**ADDENDUM NO. 1**

**To All Bidders of Beach Patrol Headquarters  
Borough of Stone Harbor  
Cape May County, New Jersey  
D&A Project #: SH-C-020**

Stone Harbor Beach Patrol Headquarters &  
 Public Restrooms  
 95th Street & Beach  
 Stone Harbor, NJ

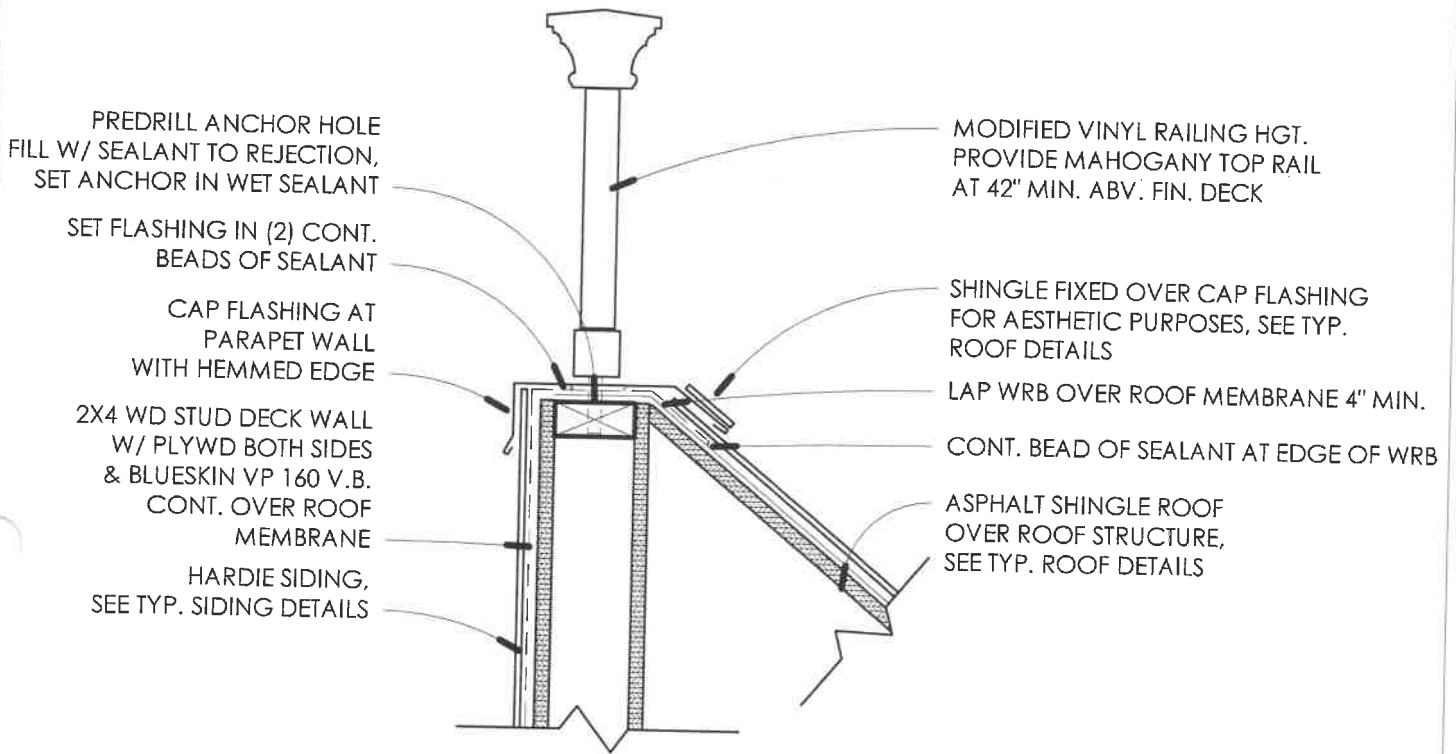
6. All exterior bearing locations for the W14 steel beams shall be supported by 5" dia. Schedule 40 steel pipe as shown on SK7.
7. The 11 7/8" TJI floor joist system between column line 4 and 6 shall be rotated on Sheet S-3 to support the deck 211 overhang at the spiral staircase.

# I DECK WALL DETAIL - CROW'S NEST

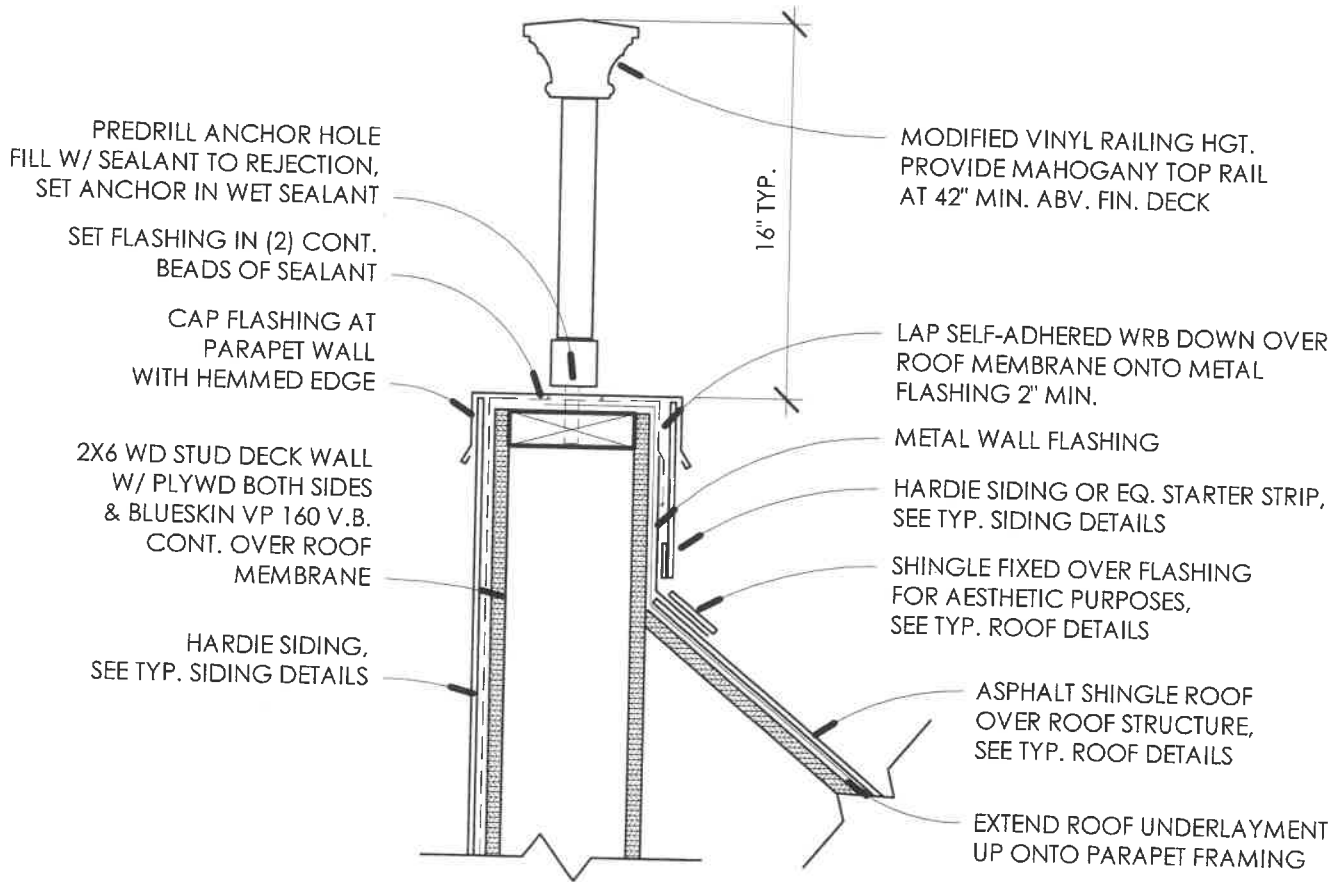
- A. **See attached SK2 and SK3.**
- Q. On drawing A1.03 Crow's Nest Plan observation deck, please show fiberglass subfloor sheathing detail. Please show exterior wall detail at railing, and how railing connects to wall. Please show flashing detail between wall and fiberglass deck.

- A. **See attached SK1 and SK4.**
- Q. Interior wall finishes WP-10 AZEK boards are called out on the finish schedule. Partition detail 140 calls for 3/8 plywood over gwb. Do we install the 3/8 azek over the 3/8 plywood?

## 2 DECK WALL DETAIL - DECK 211

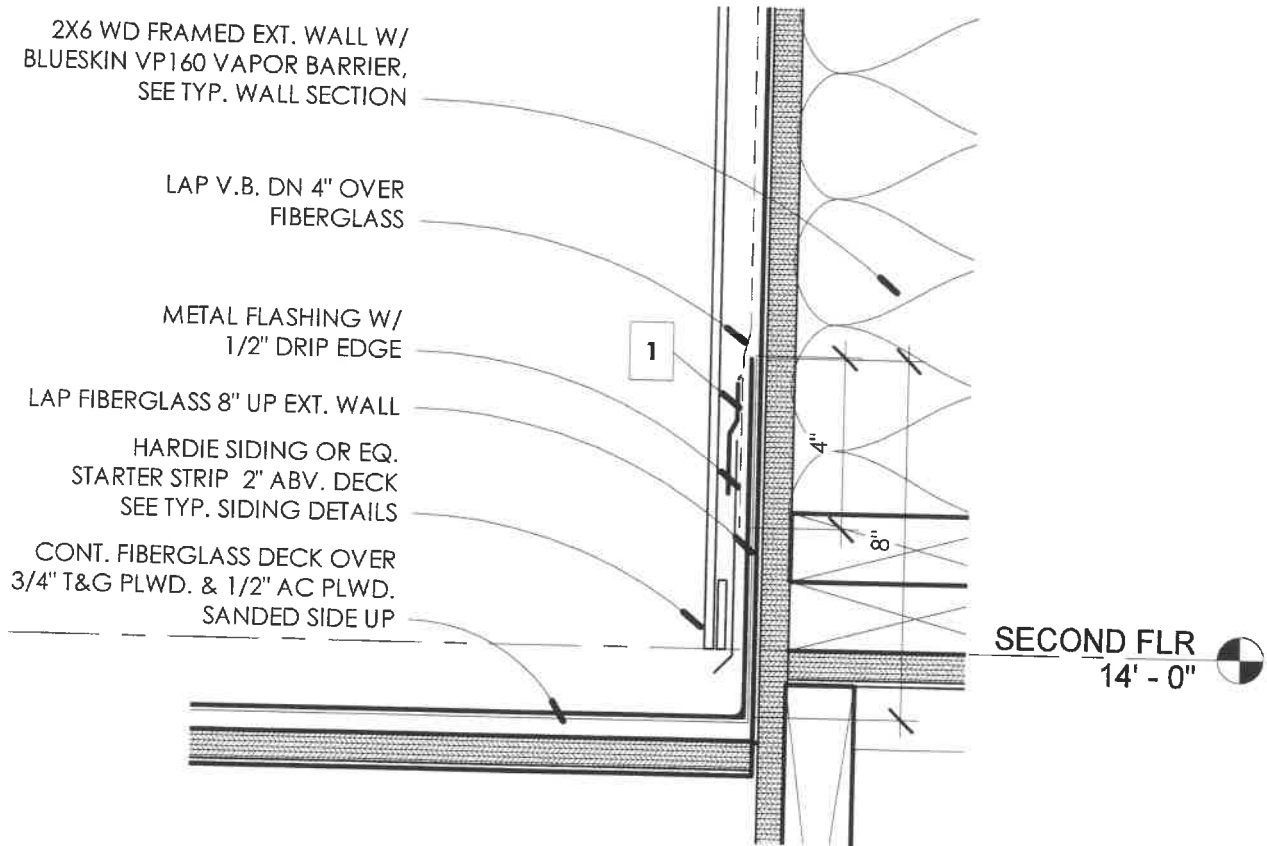
- Q. Please provide wall framing detail showing studs 2x4 or 2x6 and show connection detail of the 2x12 roof rafters at deck 211. Please provide exterior wall siding finish detail and how railing system connects to wall at deck 211. Provide detail to show how fiberglass deck interfaces with wall. Provide subfloor sheathing detail below fiberglass deck.

**EXTERIOR STAIR DETAIL**  
 SCALE: 1/16" = 1'-0"

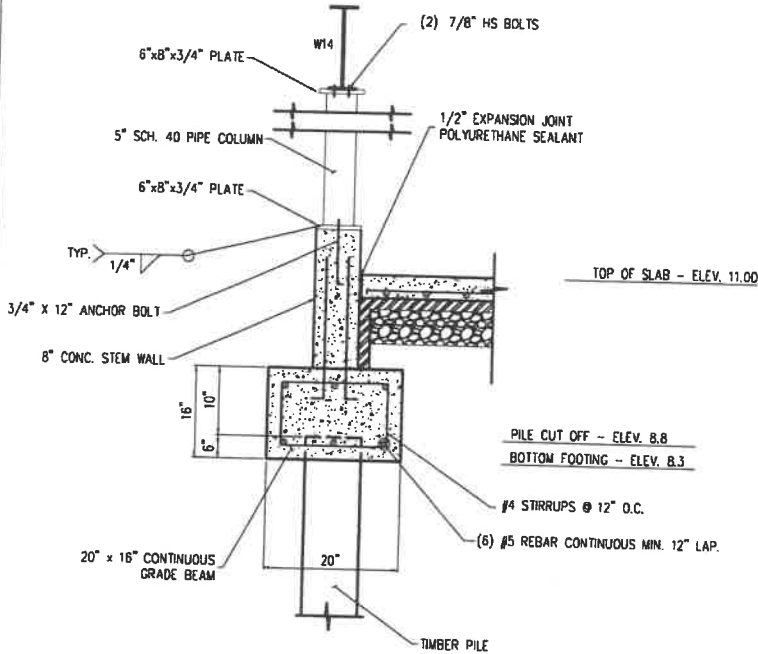
Q. Why do we need the middle Channel Stringer on the Stair? This will unnecessarily complicate how the Steel Pans fit into the stringer. Please provide a detail/sketch on how the pans tie into the center stringer. Please further clarify how the railing, treads, wood interact with the stair.

A. **The middle channel stringer is not needed and the stair system will include two outside stringers with the concrete pan tread span between. See attached SK6. Stair system to include risers.**

SK7

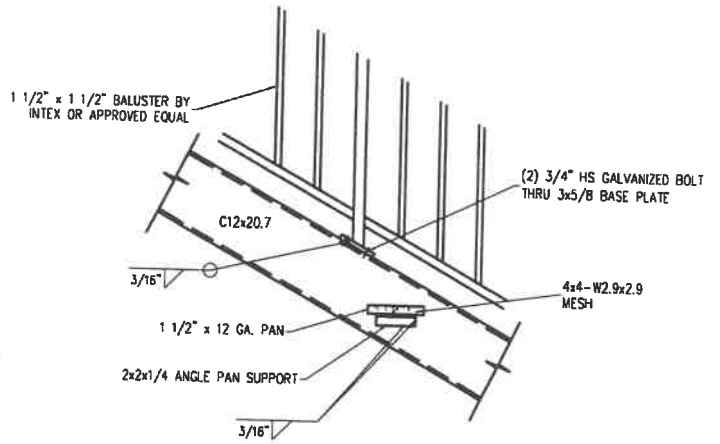
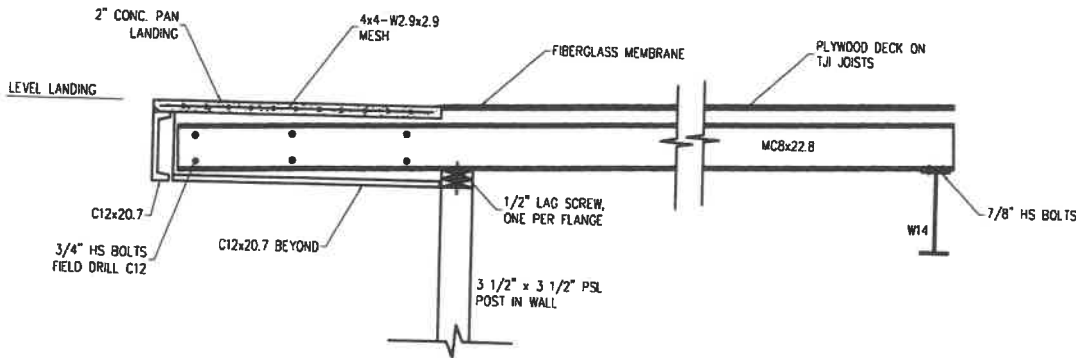
Q. How does the Steel Stair shown structurally connect to the building?

A. **See attached SK6 and SK7.**
